PARTS & SERVICE NEWS

| REF NO. | AA03033 |

SUBJECT: PARK BRAKE SOLENOID WIRING KIT

PURPOSE: To announce to the field a kit for increased park brake reliability.

FIGURE 1. PARK BRAKE SOLENOID WIRING SCHEMATIC

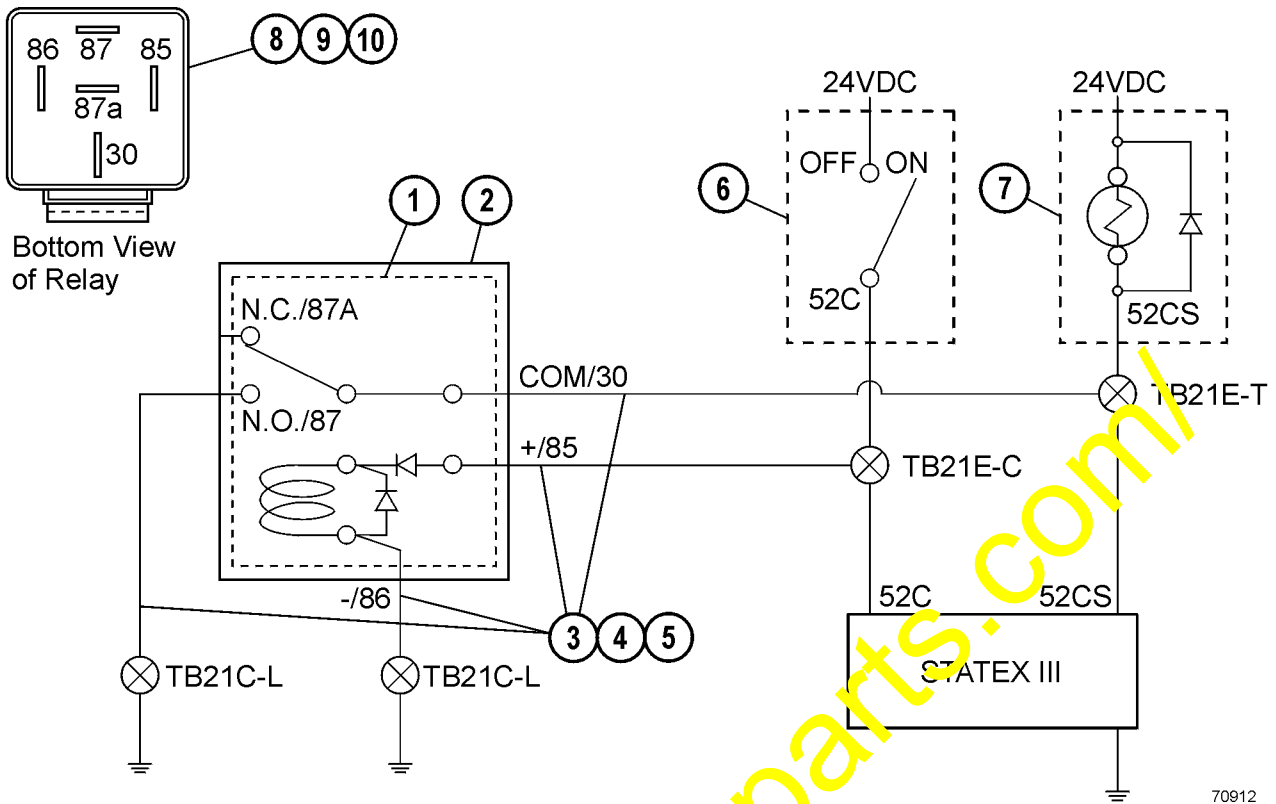
Some trucks in the field may benefit from adding a Park Brake Solenoid Kit. Kit AK4936 is for trucks equipped with relay boards, Kit AK4937 is for trucks that do not have relay boards. The Statex III system controls the application of the park brake based on input from the park brake switch and wheel speed sensors. The Statex III system provides a path to ground for the park brake relay (7, Figure 1) when the park brake switch (6) is in the "OFF" position and ground speed is zero. By adding this relay (1 or 8) to the truck, there is now a second path to ground when the park brake switch is in the "OFF" position.

These kits add reliability to the Statex III system to ensure that the parking brake will not inadvertently "apply" while the park brake switch is in the "OFF" position. These kits can be installed on any Komatsu truck that is equipped with STATEX III, or any truck that has been converted over to STATEX III. Early 830E trucks with Statex III and all trucks that have been converted to Statex III require kit (AK4937).

1. Place the battery disconnect switch in the "OFF" position.
2. Install relay (3, Figure 2) into an empty socket on Relay Board 6 or 7. If truck is not equipped with a relay board, drill a hole in a convenient location on the left side, inside wall of the control cabinet (the side near the cab) to mount the new relay (8, Figure 1).
3. Connect the relay to the truck with wire and the terminals supplied in the kit as shown in the schematic in Figure 1. If truck is not equipped with relay boards, use the terminals supplied in kit AK4937 to connect the wires to the relay socket (9).
 - a. Connect circuit 52C to the + (85) relay coil terminal.
 - b. Connect circuit 52CS to the com (30) relay terminal.
 - c. Connect the - (86) terminal to ground.
 - d. Connect the N.O. (87) terminal to ground.
